MONACO
COACH CORPORATION

VEHICLE SAFETY DEFECT SERVICE BULLETIN

Recall Campaign 06V426000 US Units

Re: Safety Recall – Steering Nut and Bolt

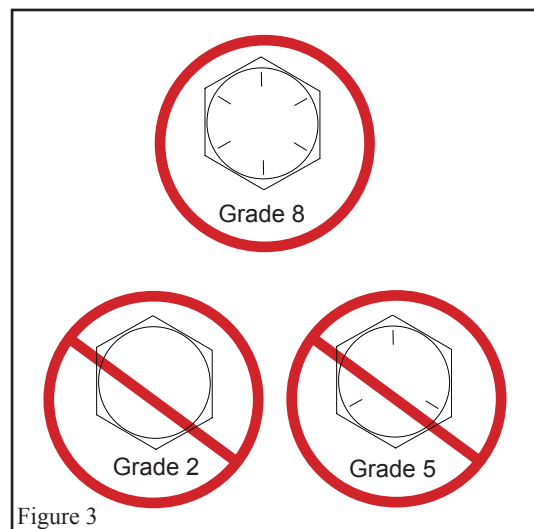
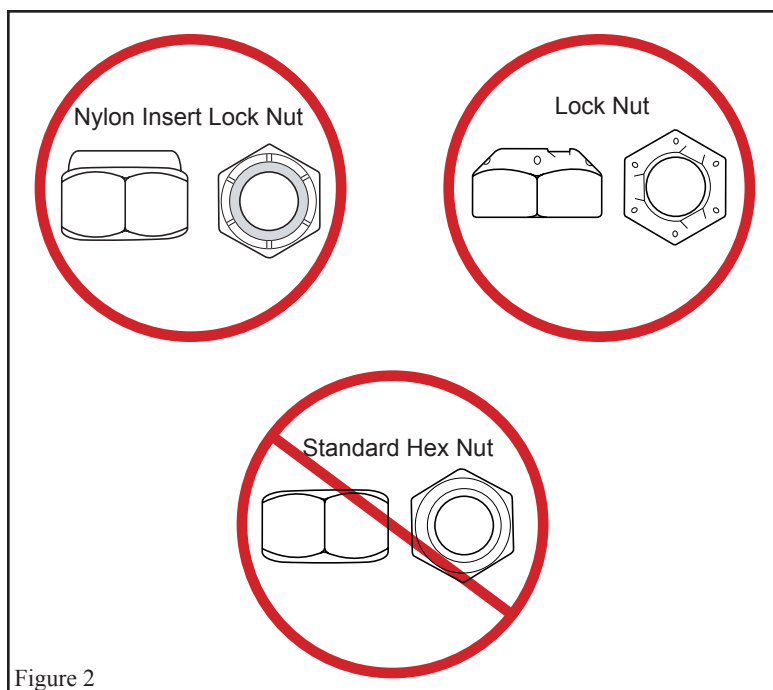
1. Remove the screws in the front of the plastic steering column surround to access the intermediate shaft.
2. Locate the bolt securing the intermediate shaft to the bottom of the steering column shaft (refer to figure 1).
3. Verify the bolt installed is a 3/8" Grade 8 bolt with a lock nut or a nylon insert lock nut (refer to figures 2 & 3 on page 2 for visual assistance). Washers may have been used with either type of lock nut and are acceptable as long as they do not interfere with the seating of the bolt or nut.
4. Any combination involving the use of a standard hex nut (non-lock type nut) is unacceptable and must be replaced with the bolt/lock nut combination provided.

1. Remove the existing bolt/nut combination and replace with the new bolt/lock nut combination provided (do not install washers with the new combination).
2. The intermediate shaft should not slide down the steering column spline shaft and the bolt must go through the machined groove in the spline shaft.
3. Torque the new bolt and nut combination to 49 ft lbs.
4. Re-secure the steering column surround.

NOTE: Re-torque every 5 years or 50,000 miles maximum. Lock nuts cannot be re-used once removed. If the new lock nut is removed for any reason, replace with a new lock nut.
